COMPLIANCE AUDIT

Leewood Ponds Water Management Facility

Santos NSW Pty Ltd

September 2015
Version 1

Plate 9 – Leewood inlet manifold and associated pumps and metering equipment

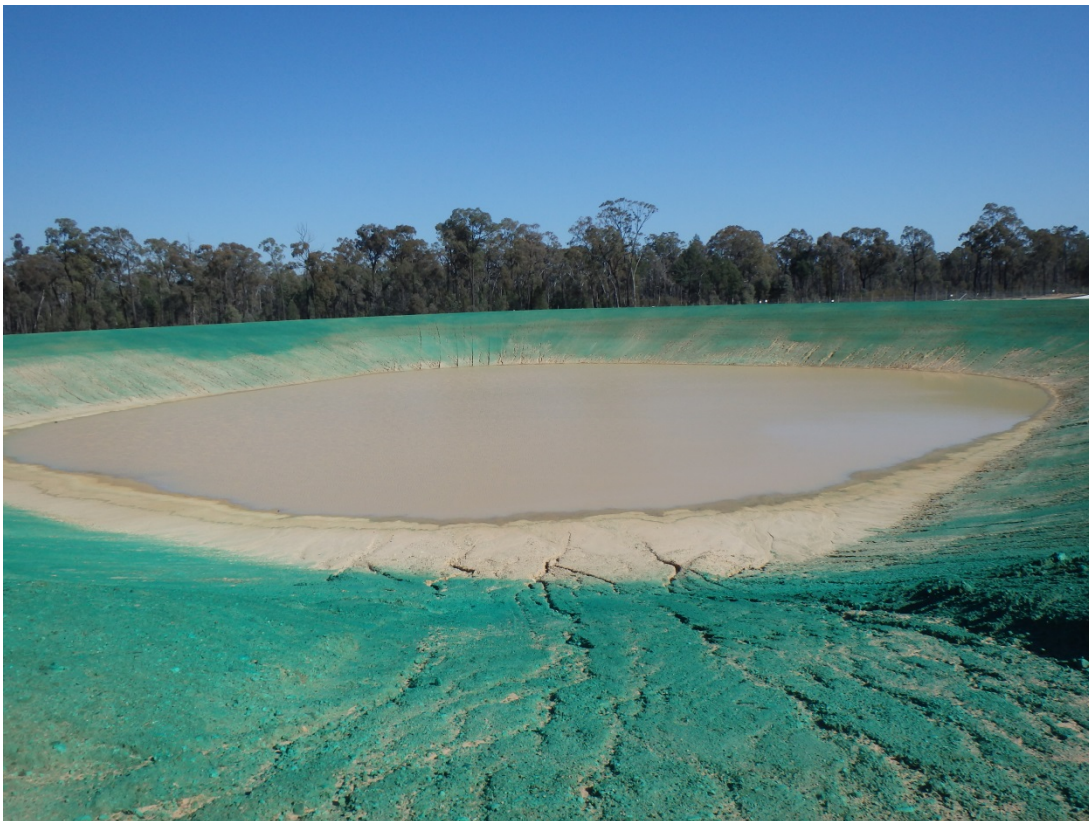
- Leewood inlet manifolds and associated pumps and metering equipment (**Plate 9**)
- Leak detection monitoring bores around the perimeter of the ponds
- Nested monitoring bores at the perimeter of the Leewood property
